STAFF REPORT
KETCHUM PLANNING AND ZONING COMMISSION
SPECIAL MEETING OF MARCH 31, 2025

PROJECT: 140 & 180 N Leadville Ave ARCH Affordable Housing Project

FILE NUMBER: P25-006

APPLICATION: Pre-Application Design Review

Figure 4: Flat Facades

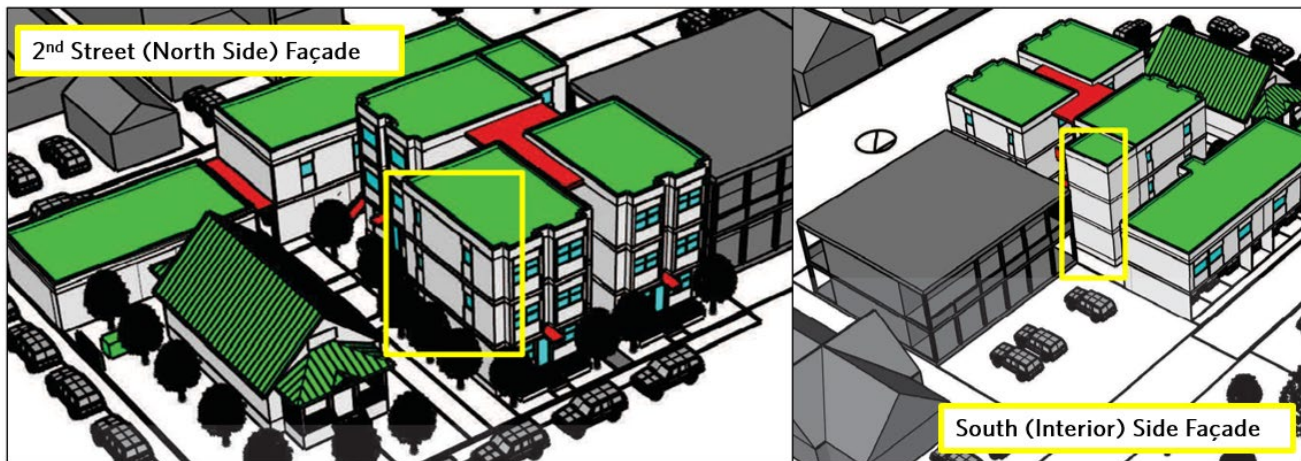
Pursuant to KMC §17.96.060.F.5, building walls shall provide undulation and relief to reduce the appearance of bulk and flatness. The three new three-story residential buildings are detached and connected by a covered external staircase. Staff believes this detached design provides relief to the mass of the three new residential buildings. IN addition, the façade design includes exterior material differentiation that provides visual relief. The front facades of the buildings include dark black/gray horizontal lap siding on the ground floor that is broken up by paned windows. The upper levels are comprised of smooth stucco that will be painted a natural beige color. The stucco is broken up by paned windows and black/dark gray board and batten vertical siding.

While Staff appreciates the visual interest provided by the exterior material differentiation, color contrast between the dark black/gray siding and lighter beige stucco, and paned windows, staff believes certain facades identified in Figure 4 appear flat and monotonous due to the height and length of certain portions of undifferentiated blank surfaces. Staff recommends the applicant consider modifications to reduce the appearance of bulk and flatness and provide more light, shadow, and texture to the façade design. In addition, staff recommends the applicant consider

providing decks or balconies/Juliet balconies for the upper-level apartments to help animate the façade and provide private open space for tenants.

A.2

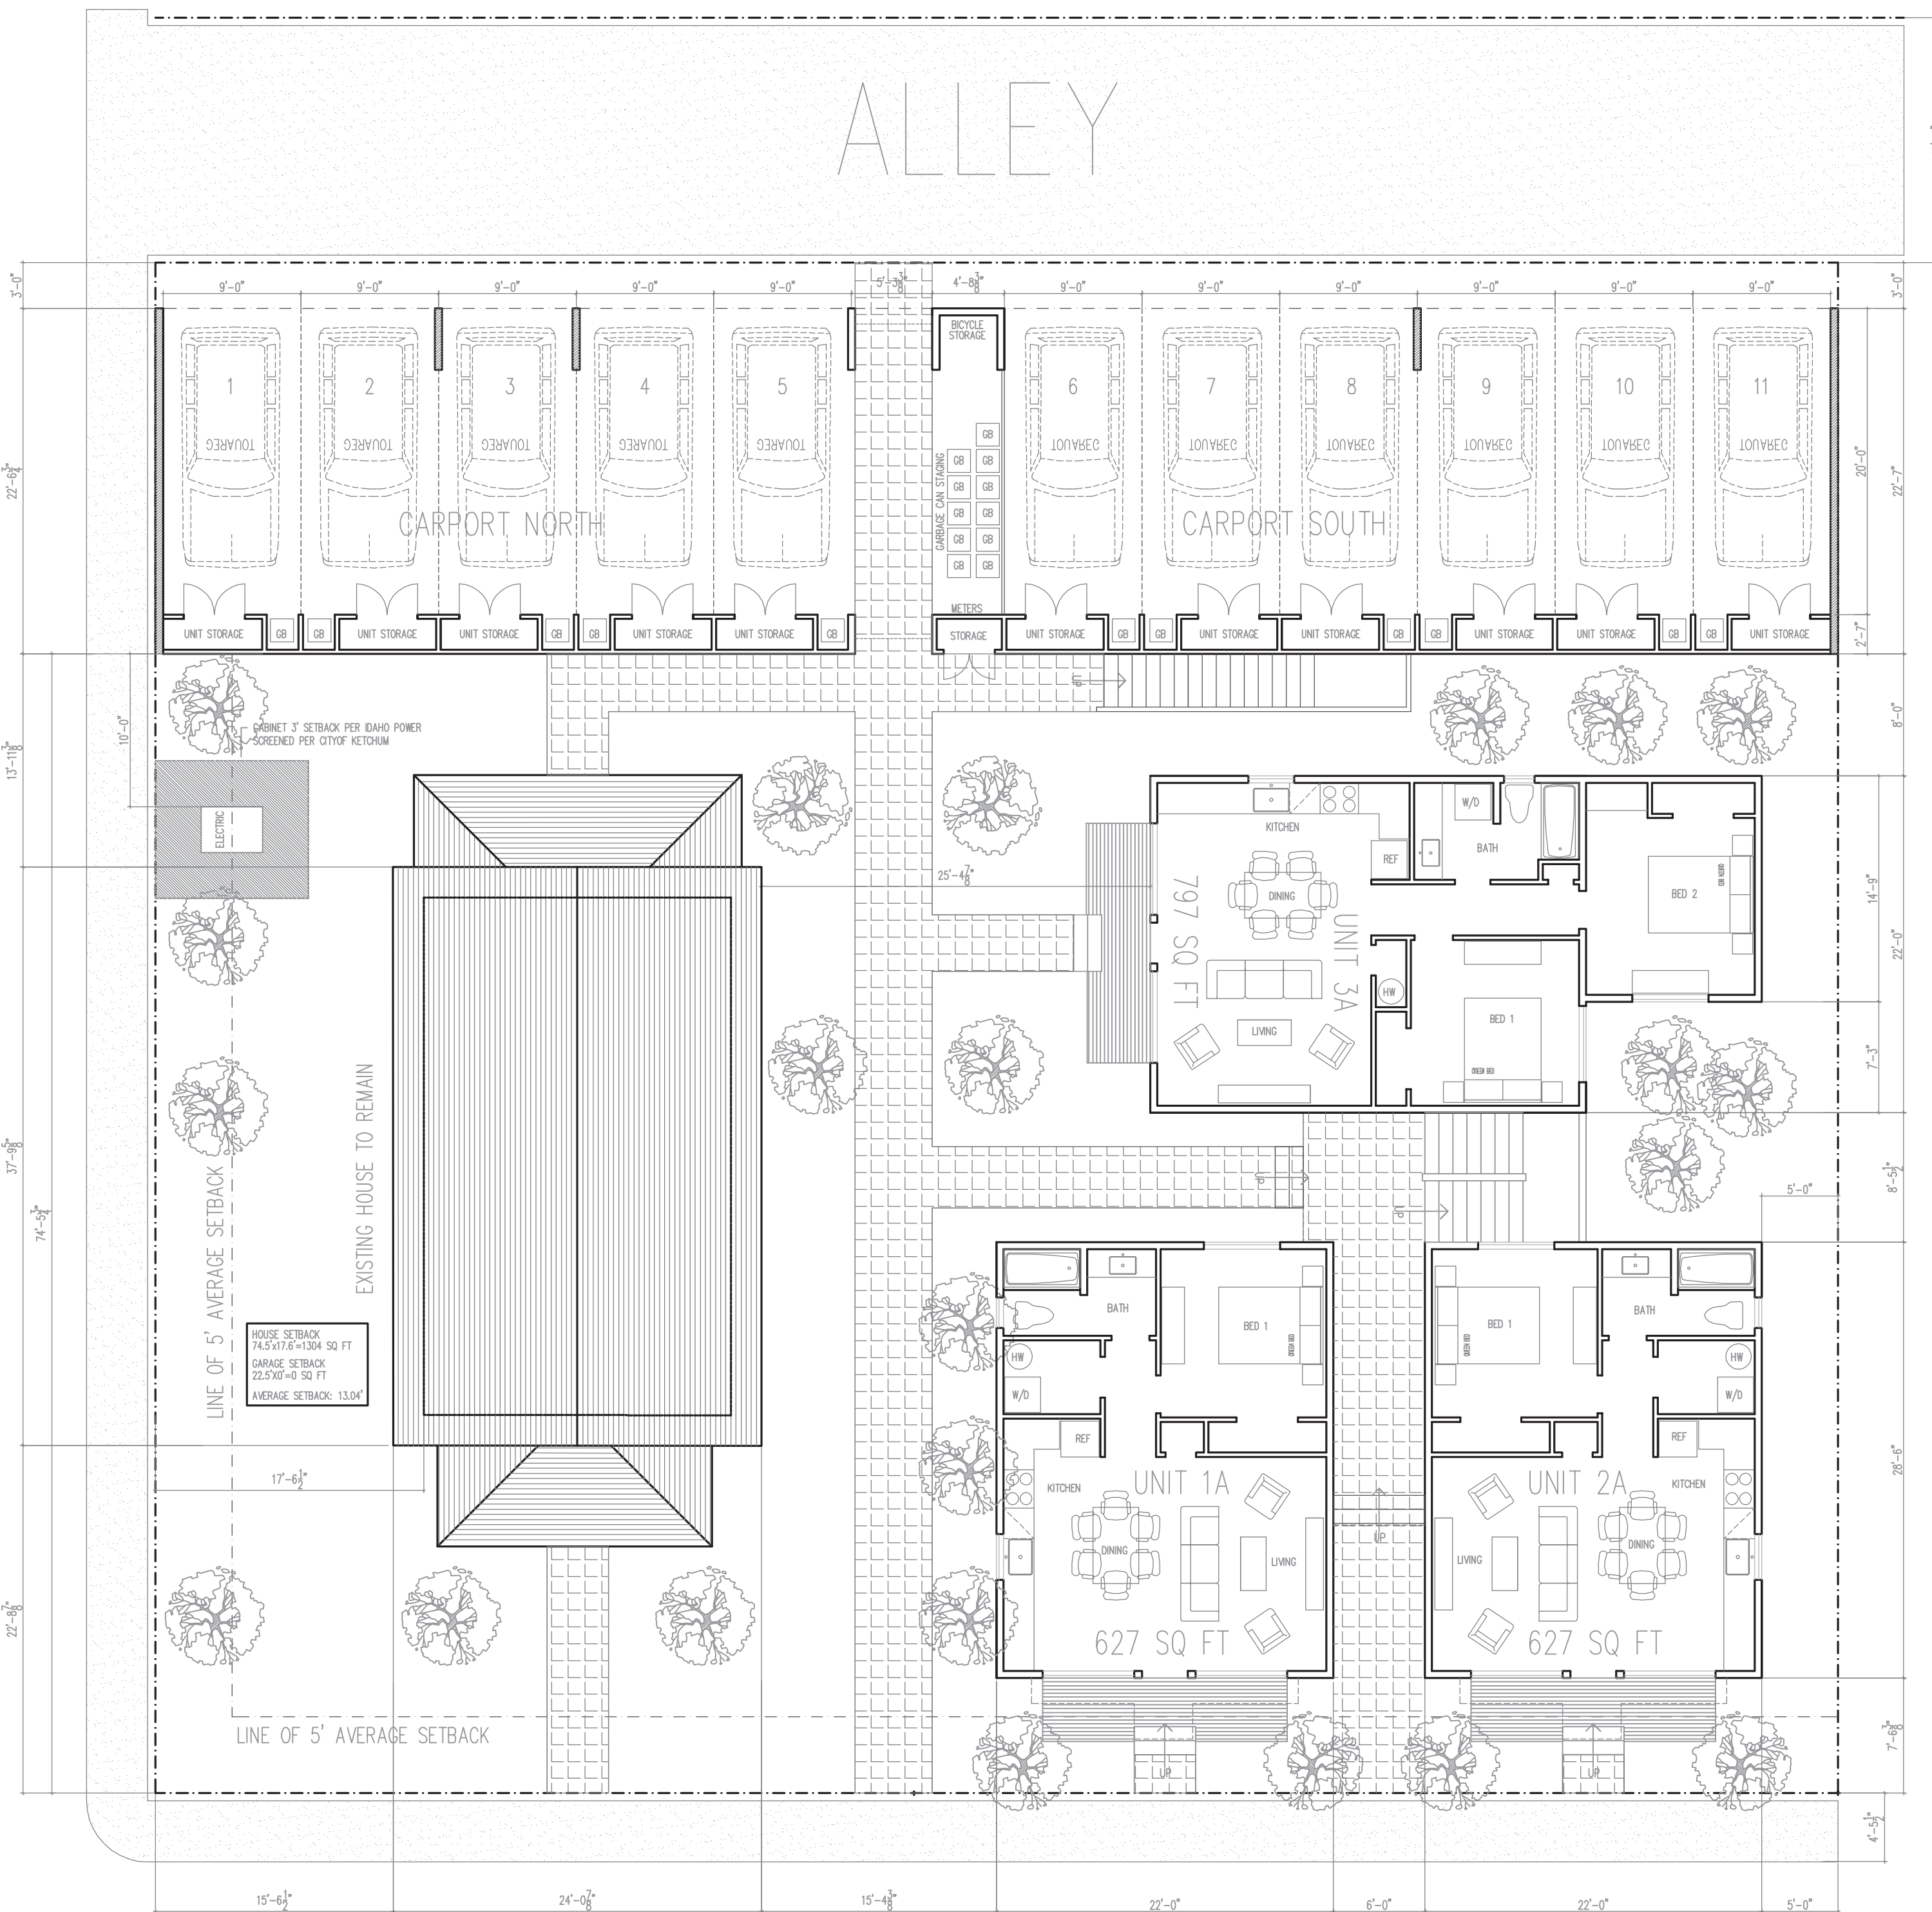
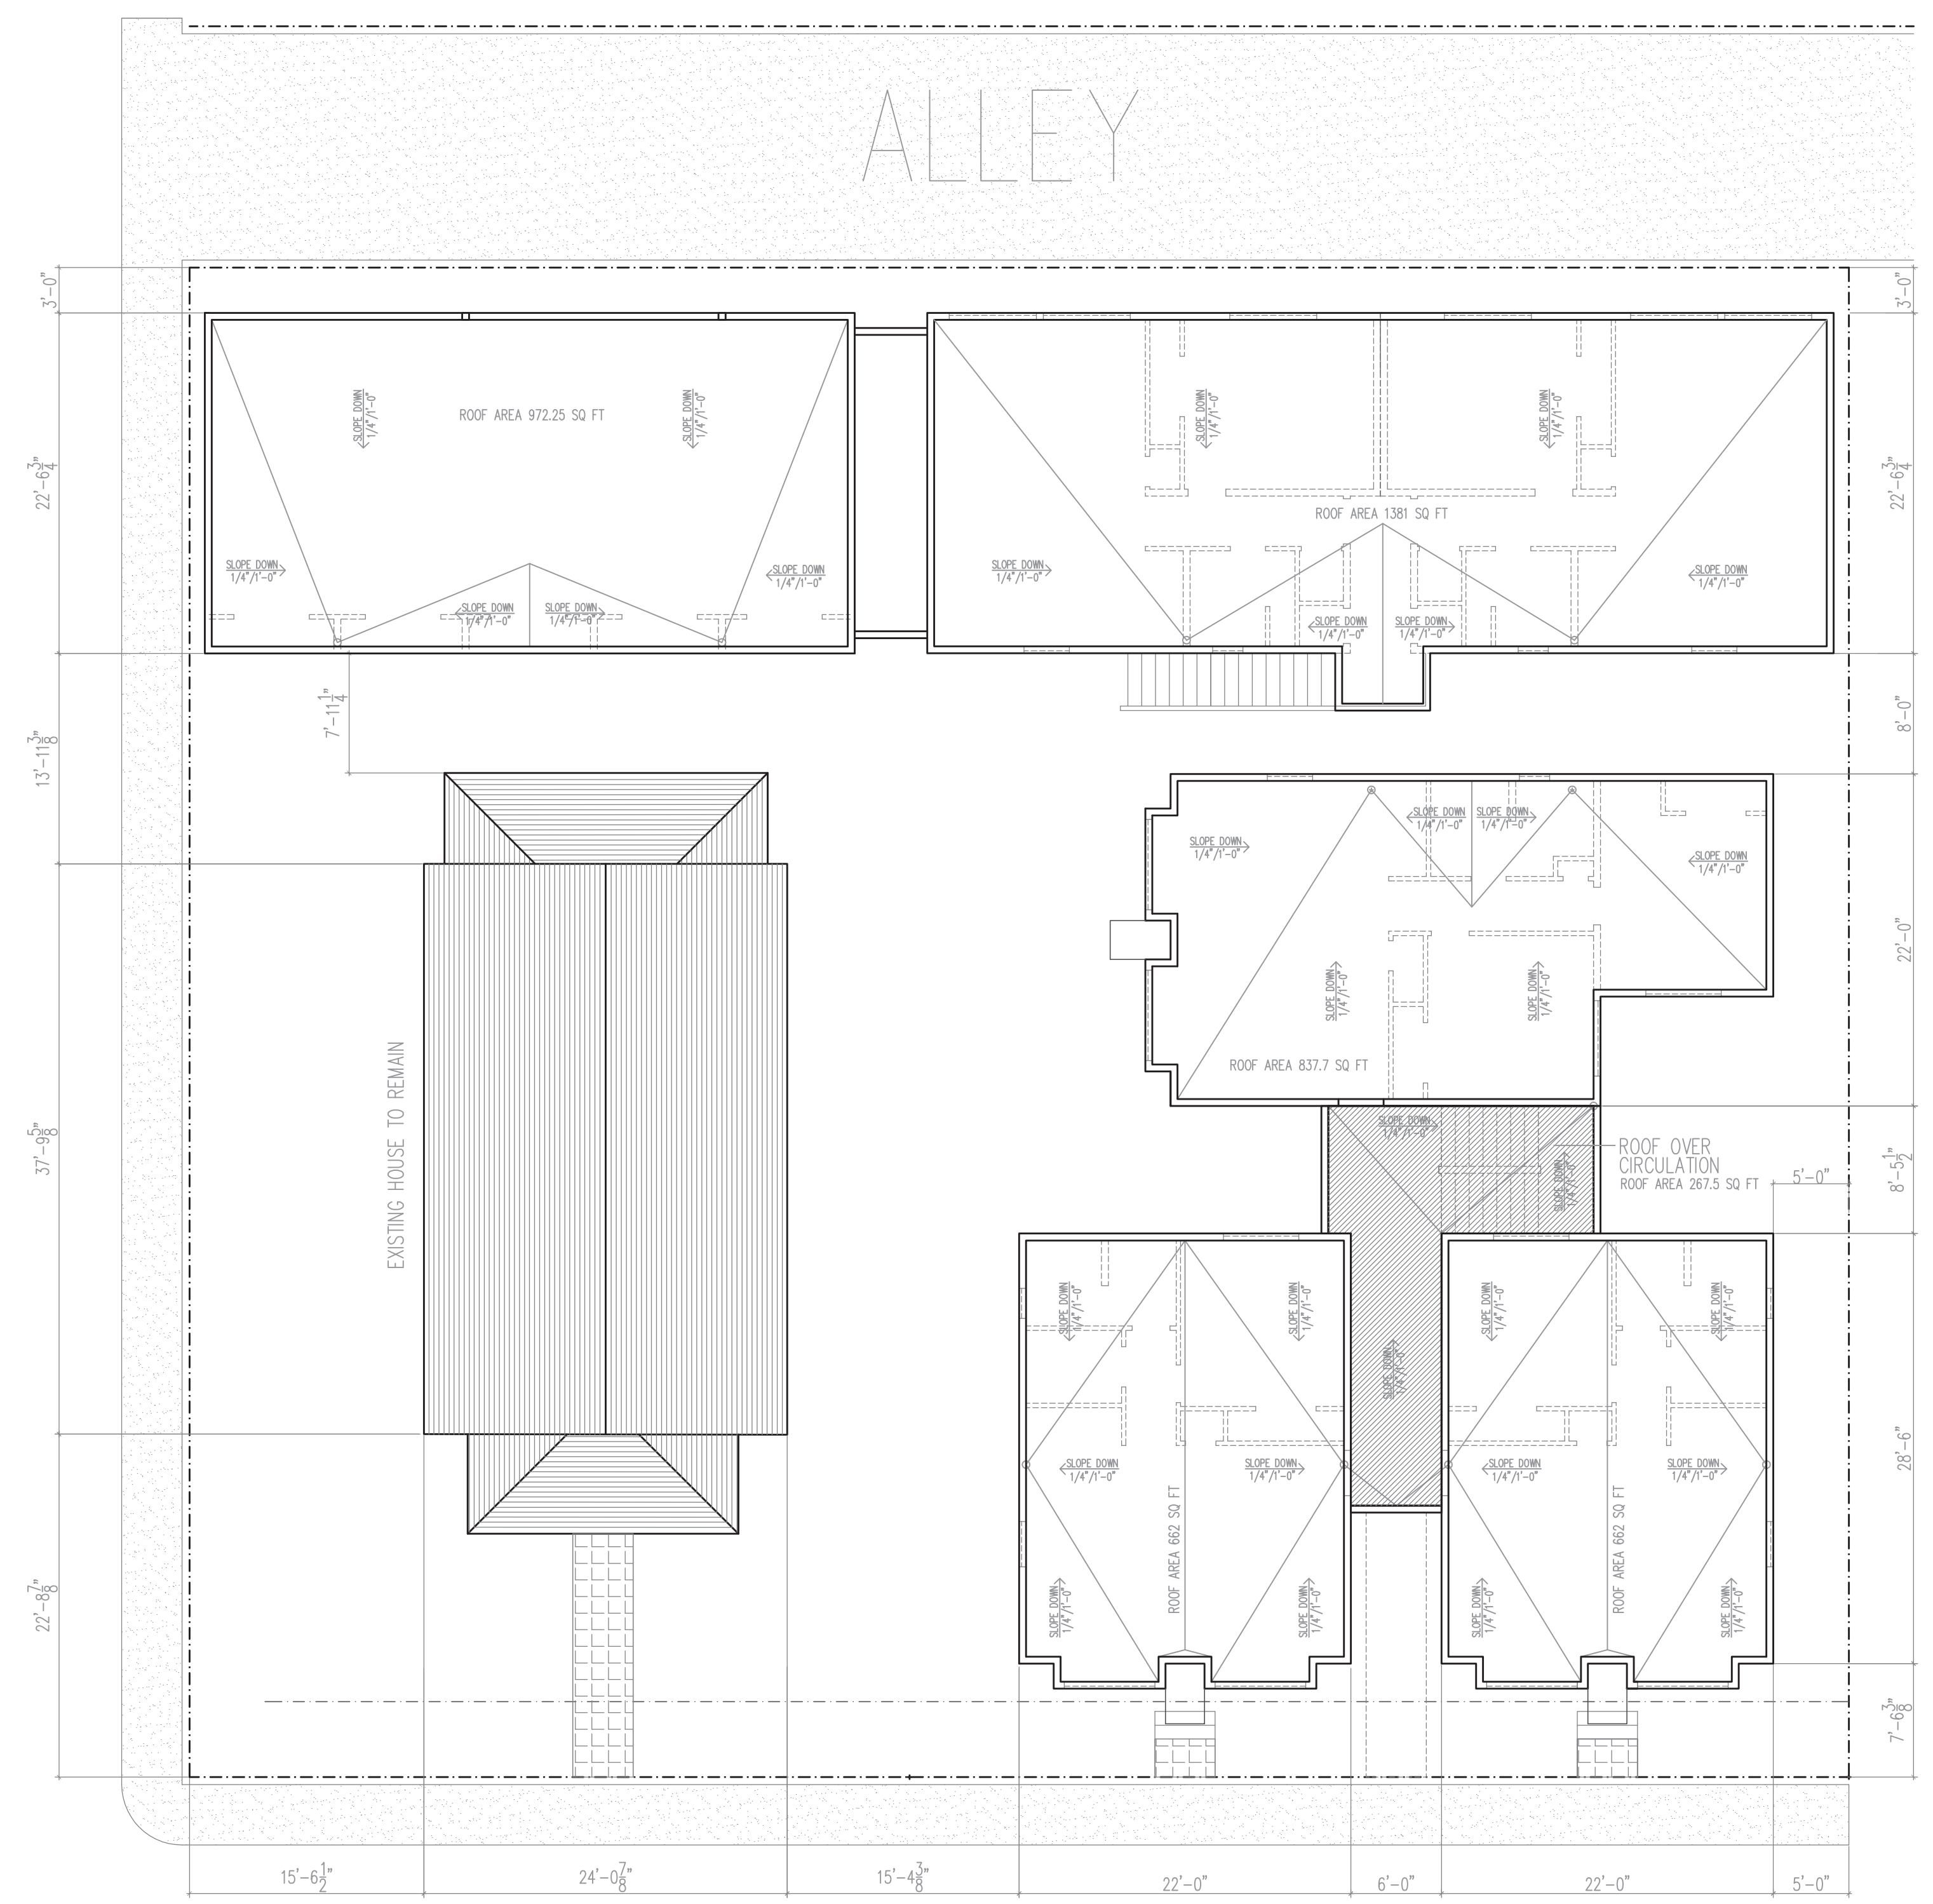
Pursuant to KMC §17.96.070.C2, “Roof and ground mounted mechanical and electrical equipment shall be fully screened from public view. Screening shall be compatible with the overall building design.” As shown on sheet A.2 of the project plans, a new transformer is proposed to be installed

by the 2nd Street sidewalk. While new transformers are encouraged to be located along the alley, the proposed siting of the new transformer accommodates more space for off-street parking. As the proposed transformer is surrounded by an open space buffer on all sides, staff believes there is sufficient area to fully screen the transformer from public view along the sidewalk.

1. Trash disposal areas and shipping and receiving areas shall be located within parking garages or to the rear of buildings. Trash disposal areas shall not be located within the public right of way and shall be screened from public views. **Yes, see sheet A.2**
2. Roof and ground mounted mechanical and electrical equipment shall be fully screened from public view. Screening shall be compatible with the overall building design. **Yes, the electrical transformer cabinet shall be screened as noted – see sheet A.2**
